Access Compliance Report

Public Rights-of-Way

(Curb Ramps)

Intersection ID: 10032503	Main Street: N_CALDWELL_ST	Cross Street: N/A	Location: W
ADA ID: 2D1A6F10B0A2	Ramp Type: PerpDiag	Initial Pass/Fail: Fail	Overall Compliance: No
Severity Score: 33.75			
Codes/Mitigation Info/Possible Solution		Field Measurements/Component Compliance

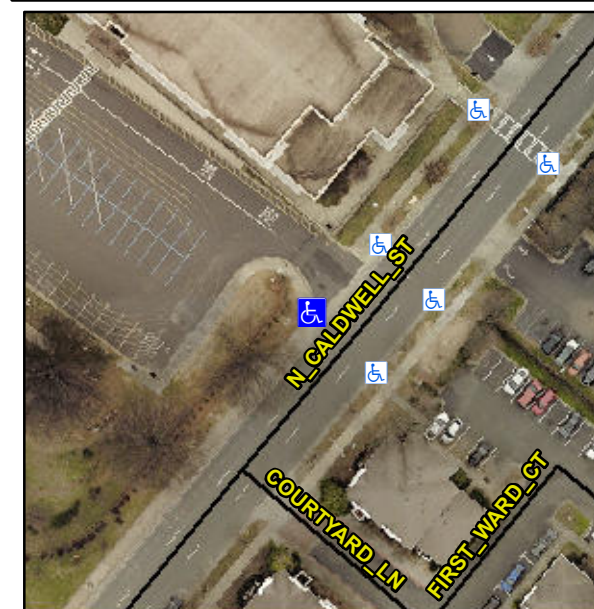
Not Found, R304.5.1, R304.2.2

Compliance	Description	Data	Compliance	Description	Data
N/A	Ramp Length (in)	48.5	No	Ramp Slope (%)	17.6
No	Ramp Width (in)	45.0	Yes	Ramp XSlope (%)	2.0
N/A	Flare Type LT	N/A	N/A	Flare Type RT	N/A
N/A	Flare Slope LT (%)	N/A	N/A	Flare Slope RT (%)	N/A
N/A	Flare Traversable LT?	N/A	N/A	Flare Traversable RT?	N/A
N/A	Landing Length (in)	N/A	N/A	DWS Provided?	N/A
N/A	Landing Width (in)	N/A	N/A	DWS Contrast?	N/A
N/A	Landing Slope (%)	N/A	N/A	DWS Length (in)	N/A
N/A	Landing X Slope (%)	N/A	N/A	DWS Full Width?	N/A
N/A	Landing Curb? (Y/N)	N/A	N/A	DWS Offset (in)	N/A
N/A	Shared Landing?	N/A			
N/A	Gutter Ponding?	N/A	N/A	Gutter Slope (%)	N/A
N/A	Gutter Lip Ht (in)	N/A	N/A	Gutter X Slope (%)	N/A
N/A	Painted X Walk1?	No	N/A	Painted X Walk2?	No
	X Walk 1 Direction	To SE		X Walk 2 Direction	To NE
N/A	X Walk 1 Width (in)	N/A	N/A	X Walk 2 Width (in)	N/A
	X Walk 1 Slope (%)	1.3		X Walk 2 Slope (%)	0.6
	X Walk 1 X Slope (%)	2.7		X Walk 2 X Slope (%)	4.6

Remove & Replace Curb Ramp With Two New Directional Ramps or Equivalent.
